AIRMEN ESTATES SUBDIVISION, **FIRST ADDITION**

APPLICATION NUMBER 2 DATE September 4, 2014

DETAIL SITE PLAN

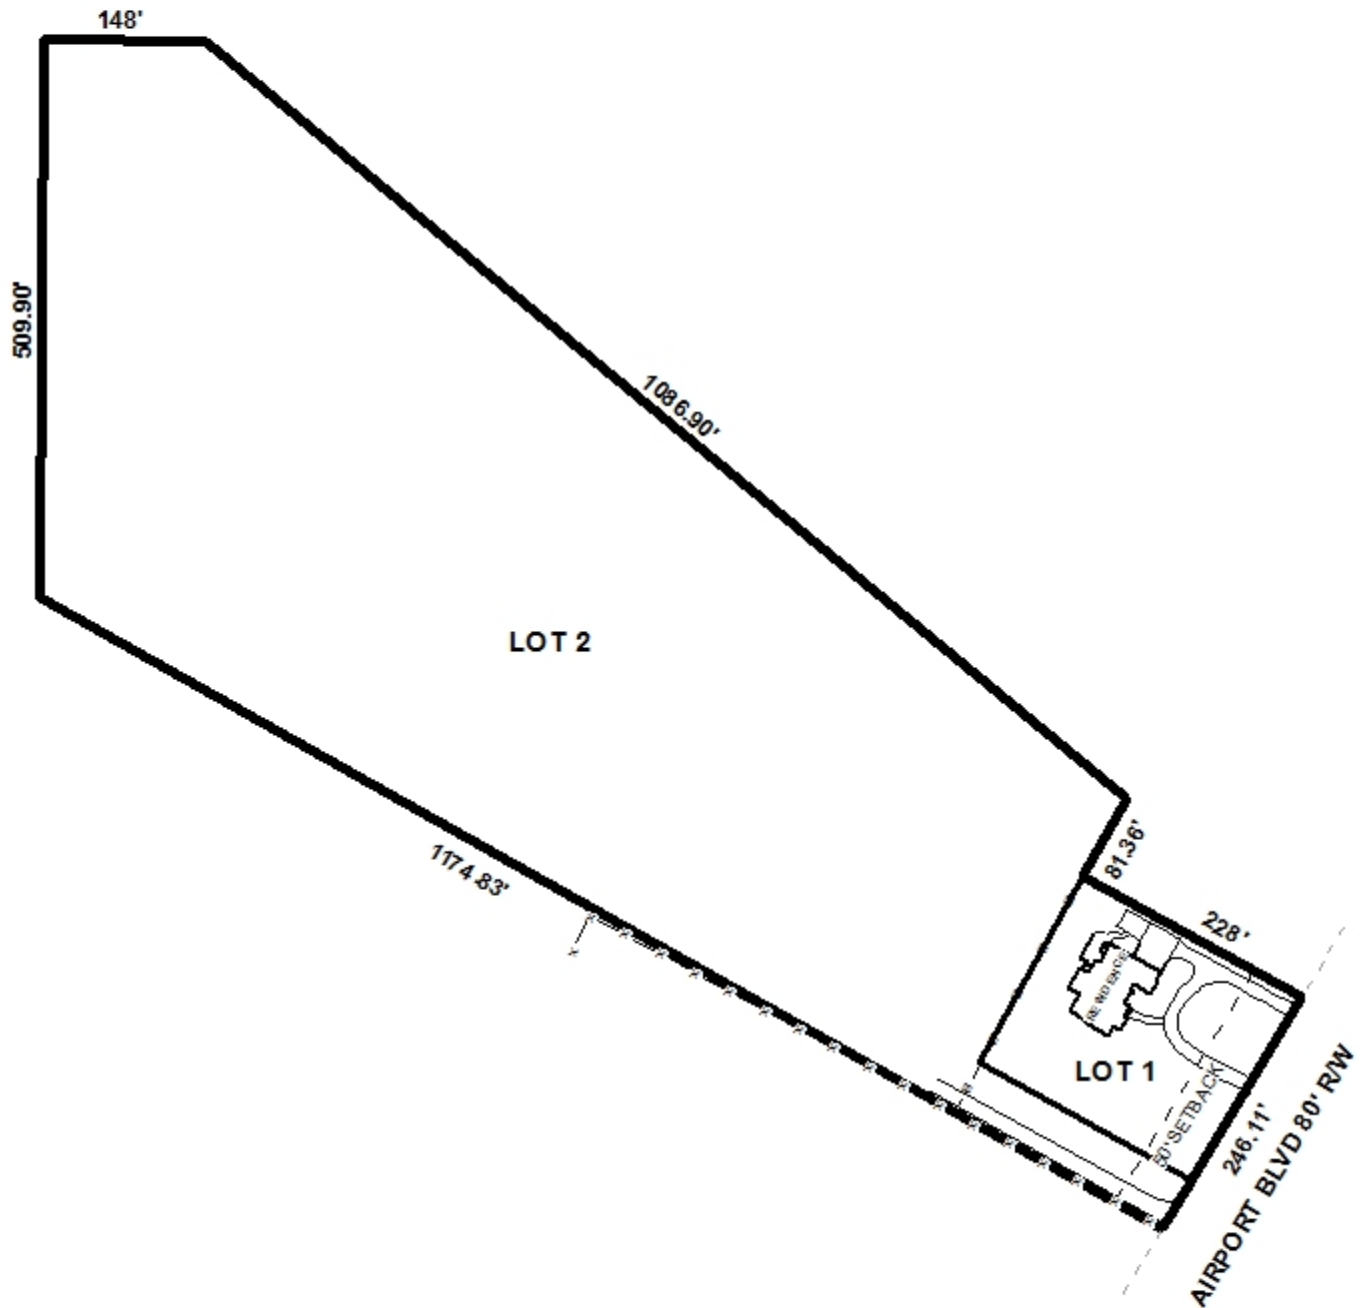
In accordance with the Subdivision Regulations, both proposed lots exceed the minimum size requirements; however, it should be pointed out that the proposed Lot 2 appears irregular in shape and, as the Subdivision Regulations govern lot character, flag lots may be permitted by the Planning Commission with a waiver of Section V.D.1. The applicant's justification for the creation of a flag lot states that the intent is to divide his residence on the proposed Lot 1 from his business on the proposed Lot 2. The proposed Lot 2 would also require a waiver of Section V.D.3. for approval due to its depth-to-width ratio and due to the limited frontage provided, a future subdivision of the proposed lot should be prohibited until additional frontage on a public or private street is provided. A note regarding this requirement should be placed on the Final Plat, if approved.

A 50' minimum building setback line is illustrated on the preliminary plat but should be revised for the proposed Lot 2 and depicted as a box where the "Flag" meets the "Pole" of the lot, and retained elsewhere on the Final Plat, if approved.

It should be noted that the legal description does not appear to list the entire southwestern property line for the proposed Lot 2 and a portion of the southeastern property line listed as *NORTH 28°43'18" EAST*. If approved, both discrepancies should be corrected on the Final Plat.

This site is located in the County, and therefore any lots which are developed commercially and adjoin residentially developed property must provide a buffer, in compliance with Section V.A.8. of the Subdivision Regulations. It appears that a portion of the proposed Lot 2 may already be commercially developed and, as such, a buffer should be provided where the proposed lot abuts residentially developed property. Notes and illustration regarding this requirement should appear on the Final Plat, if approved.

- 2) Revision of the 50' minimum setback line for Lot 2 to be depicted as a box where the "Flag" meets the "Pole" of the lot and revised for Lot 1 on the Final Plat to reflect dedication;

- 3) Revision of the lot size information for both lots to reflect dedication;
- 4) Placement of a note on the Final Plat stating that no future subdivision of Lot 2 until additional frontage on a paved private or public street is provided;

- 5) Depiction of a buffer on Lot 2 where it abuts residentially developed property, in compliance with Section V.A.8. of the Subdivision Regulations;
- 6) Revision of the Final Plat and legal description to correct all discrepancies for Lot 2;
